Nebraska Public Power District

NLS2004122
October 25, 2004

Subject: License Amendment Request to Revise the Required Channels Per Trip System for Primary and Secondary Containment Isolation and Control Room Emergency Filter System Instrumentation,
Cooper Nuclear Station, NRC Docket 50-298, DPR-46

Cooper Nuclear Station, NRC Docket 50-298, DPR-46

FIGURE 1 - PCIS GROUP 2 REACTOR WATER
LEVEL/DRYWELL PRESSURE INSTRUMENTATION

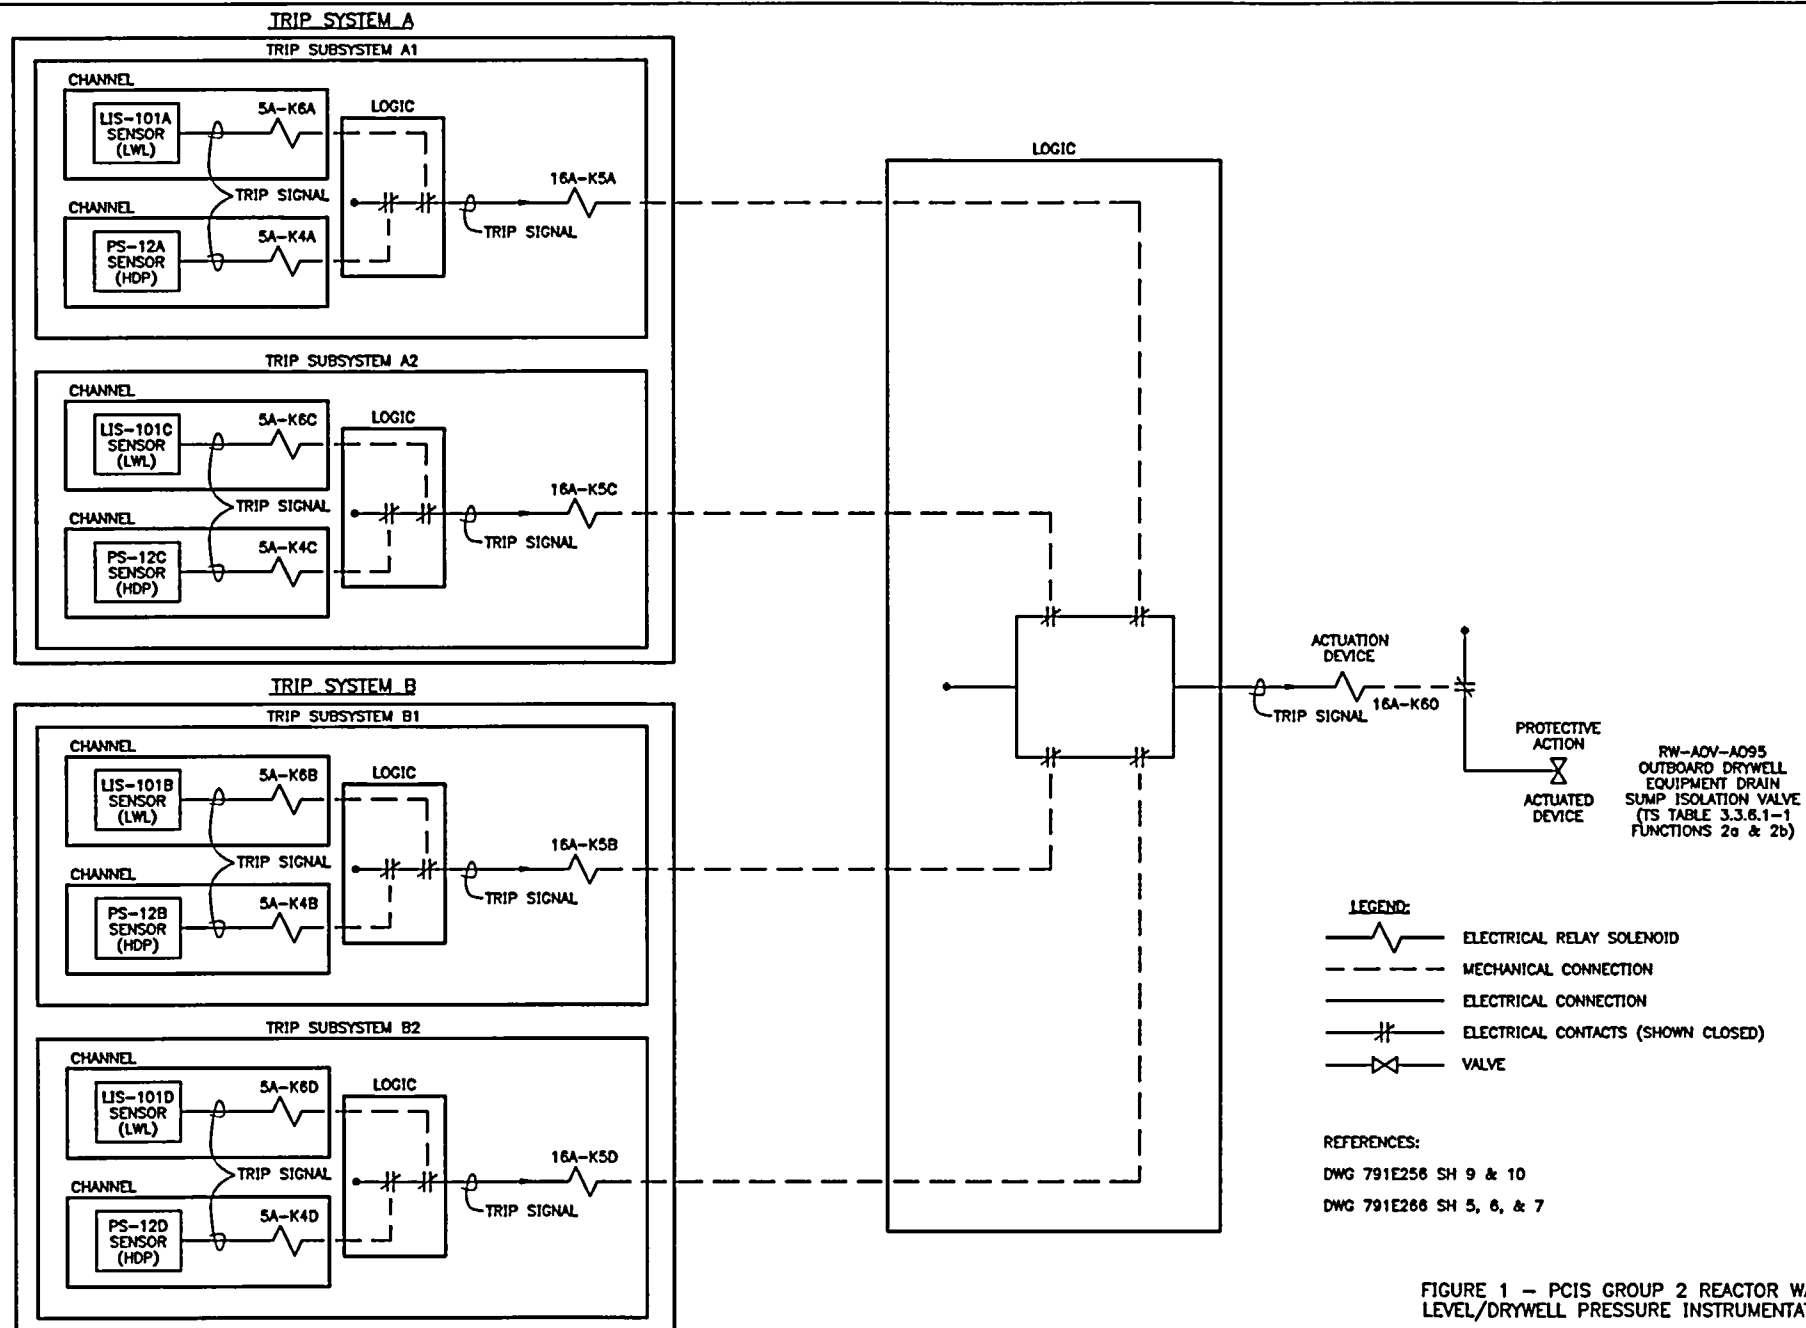
Attachment 5, Figure 1 shows the channels, trip systems, and logic arrangement for a Group 2 PCIS signal. From this figure it can be seen that there are two Trip Systems that input into one trip logic associated with the actuated device, and that each Trip System is composed of two Low Reactor Water Level Channels, and two High Drywell Pressure Channels. Although this logic is replicated for the inboard isolation valve, there is a total of four channels per instrument function (not eight as described in the TS Bases) since there are only four sensors for drywell pressure and reactor water level, respectively.

FIGURE 2 - PCIS GROUP 6 REACTOR WATER
LEVEL/DRYWELL PRESSURE INSTRUMENTATION

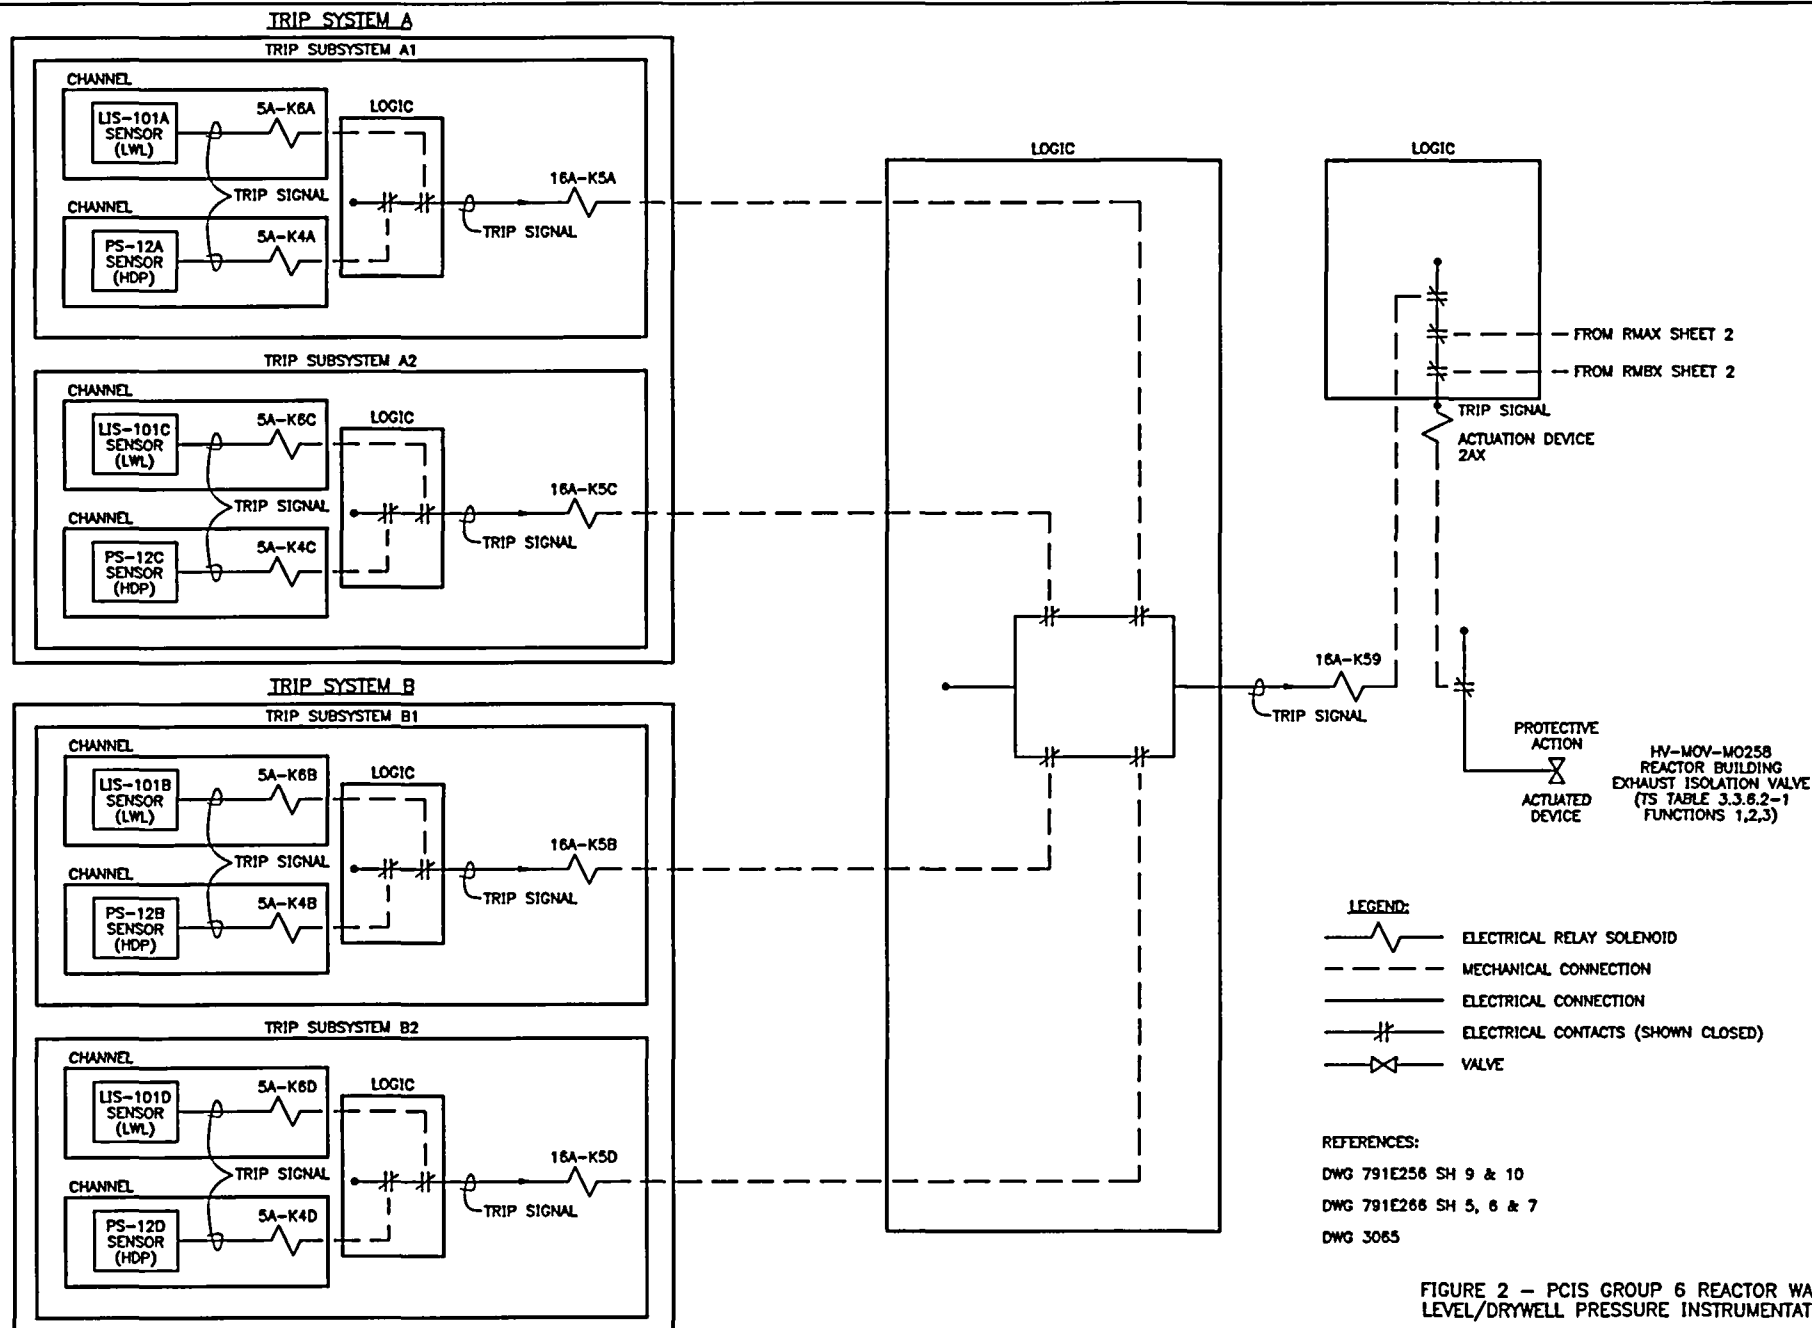
Attachment 5, Figures 2 and 3 show the channels, trip systems, and logic arrangement for a Group 6 PCIS signal. The arrangement of the Reactor Low Water Level and High Drywell Channels are identical to Figure 1. The Reactor Building Ventilation Exhaust Plenum Radiation High Channels are similarly arranged as two Channels per Trip System with a one-out-of-two taken twice logic.
